BRUSH CREEK 3RD ADDITION

Re: S/D 98-26 -- One-Step Final Plat of BRUSH CREEK 2ND ADDITION

STAFF REPORT

S/D 98-26 - BRUSH CREEK 2nd ADDITION

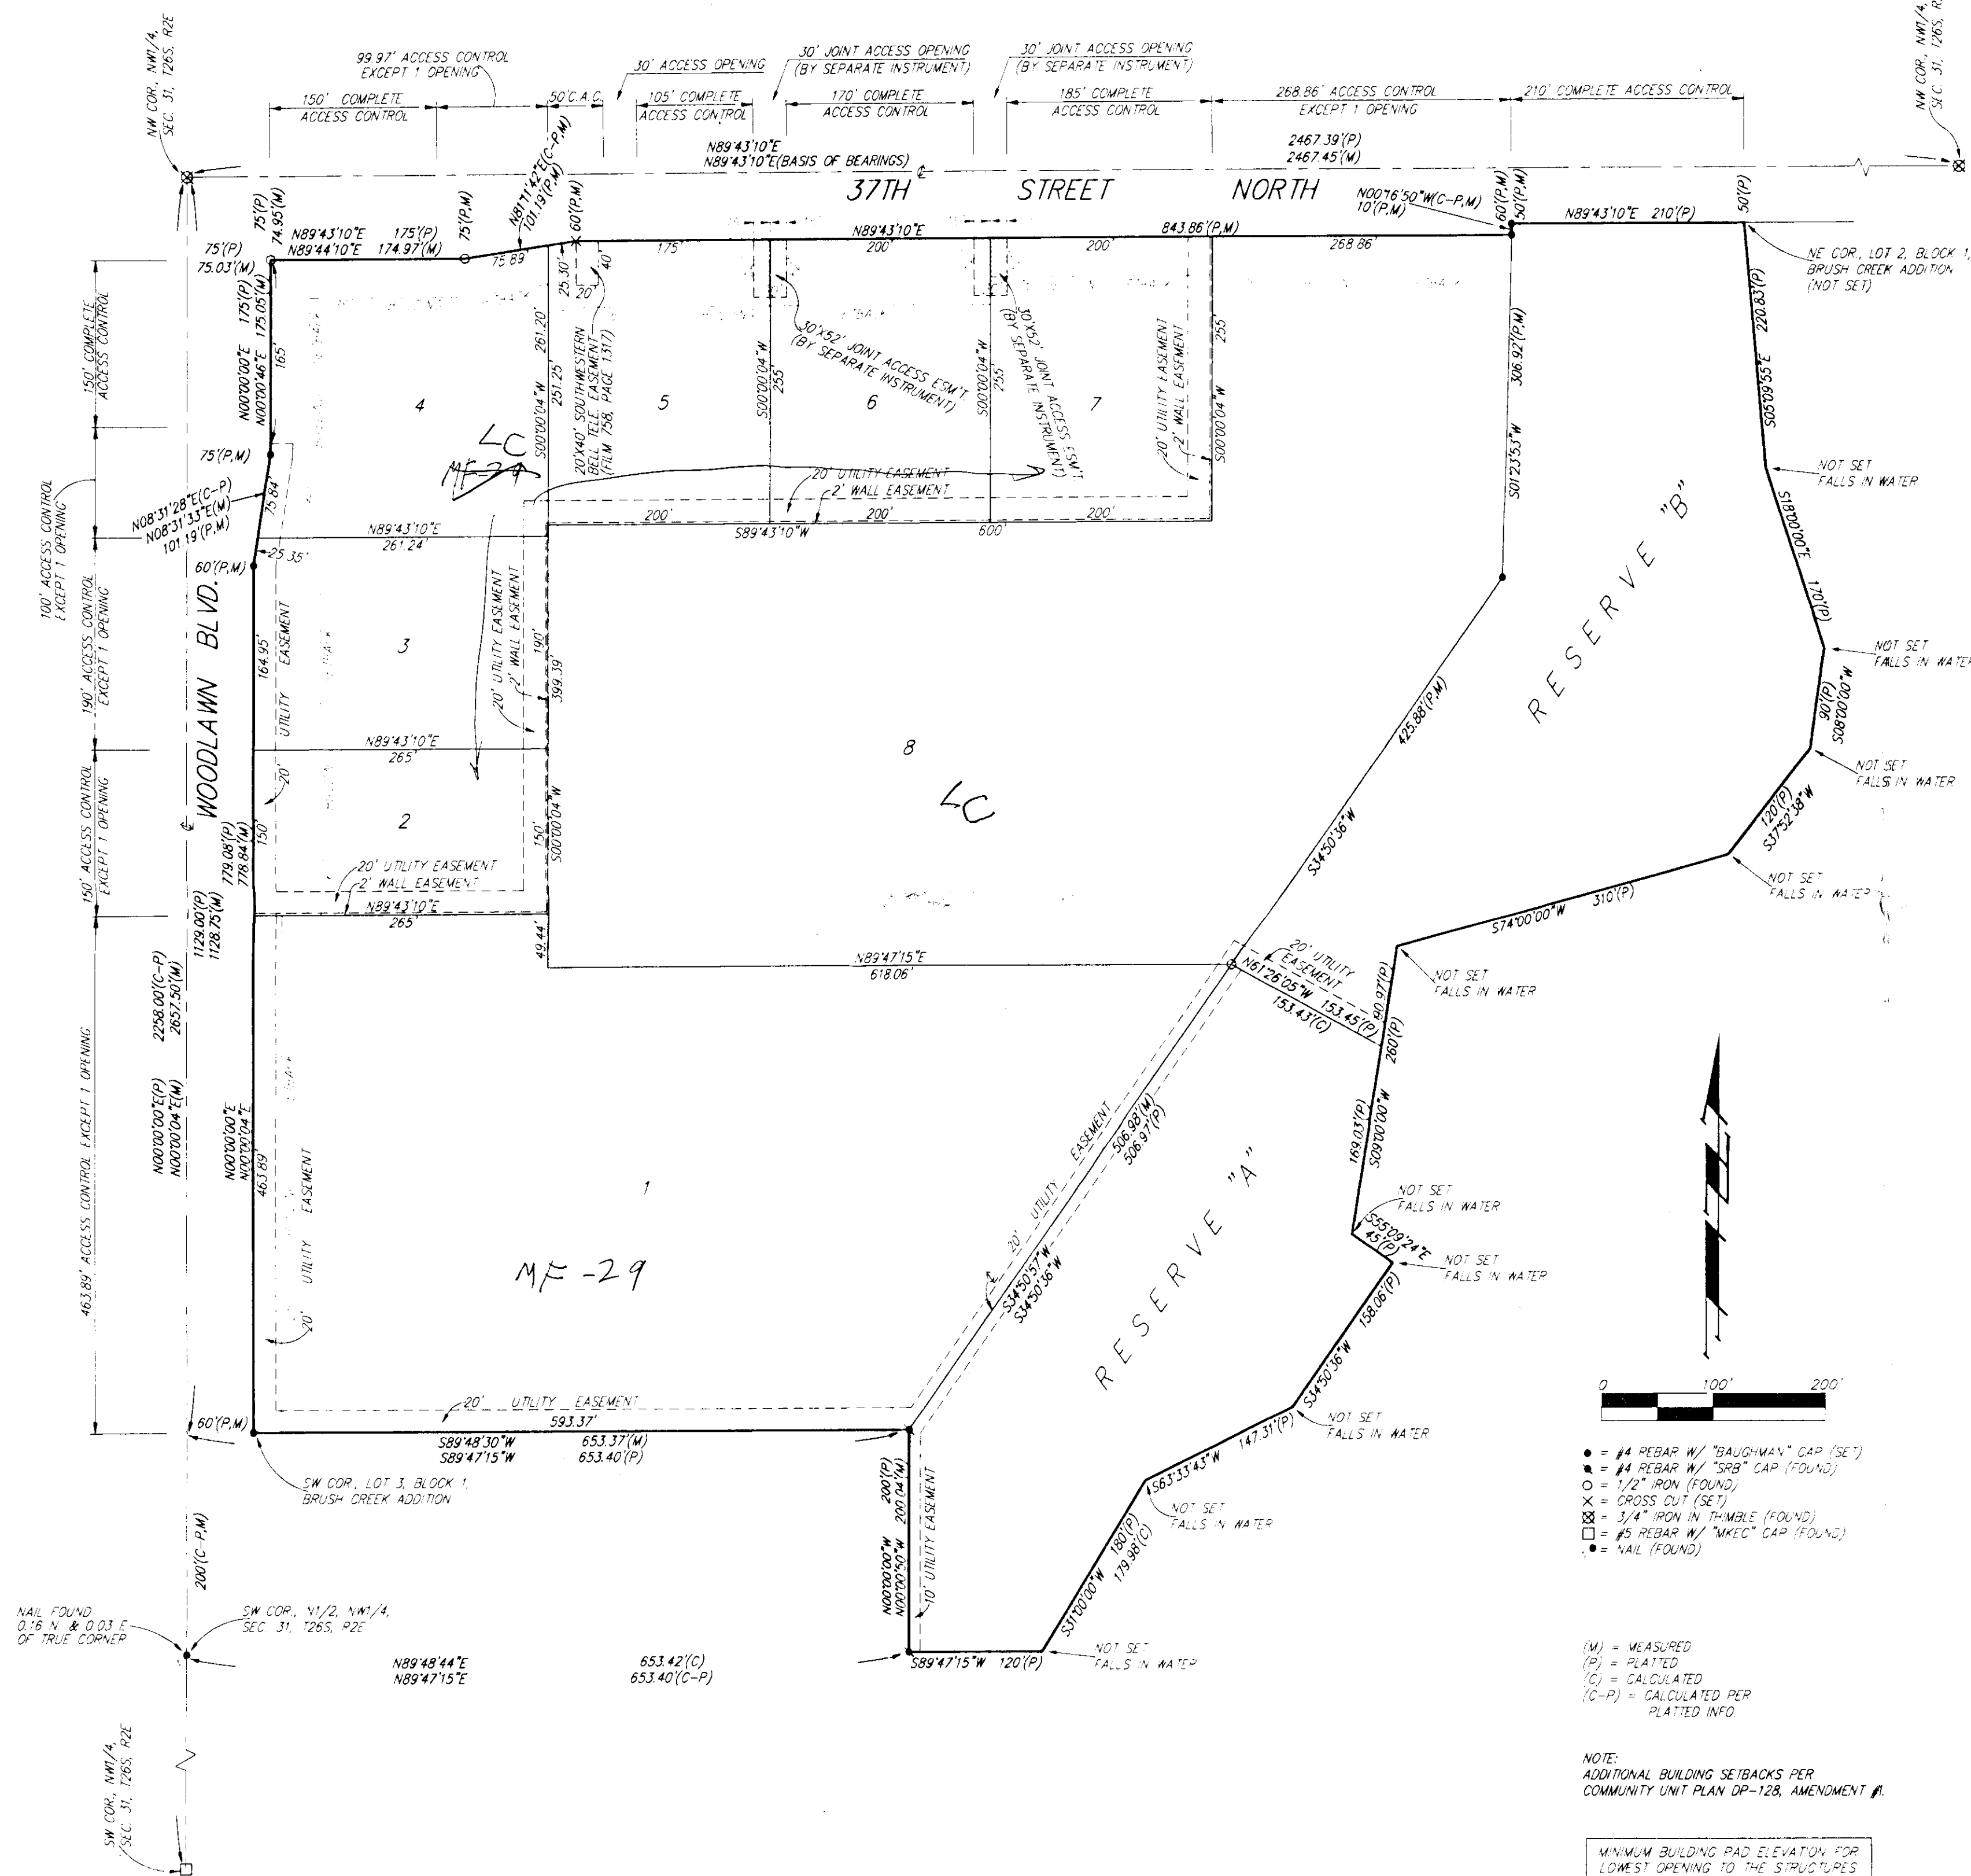
- A. Existing municipal services appear to be available to this site. City Engineering needs to indicate if any other guarantees are required. *A guarantee for sanitary sewer extension is required. A cross-lot drainage agreement is required.*

- C. The final tracing should be submitted with a revised name as an Addition now exists with the name "Brush Creek 2nd Addition".
- D. City Engineering needs to comment on the status of the applicant's drainage plan along with the minimum building pad elevations denoted on the plat. *A guarantee for drainage improvements will be required.*

- E. A condition of the CUP was that the access controls *would* be determined at the platting stage. The plat denotes one access opening for the multi-family lot (Lot 1) along Woodlawn. Lots 2, 3 and 4 are platted with one opening for each lot along Woodlawn. Five openings along 37th Street North have been denoted on the plat. The Subdivision regulations encourage shared access points for multiple lot commercial subdivisions along arterials. Traffic Engineering needs to comment on the recommended location of said joint access openings. *Traffic Engineering has approved the access controls as platted.*

- F. The plat shall denote 150 feet of complete access control at the corner of the intersection of Woodlawn and 37th St. North.

- V. The representatives from the utility companies should be prepared to comment on the need for any additional utility easements to be platted on this property. Southwestern Bell has requested additional easements.

- X. The applicant has indicated a revision in lot sizes will be denoted on the final plat tracing, and a CUP adjustment will be requested. The north-south dimension of Lot 2 will be revised from 173 to 150 feet. Ten (10') feet of Lot 8 will encroach into Lots 5, 6, and 7.
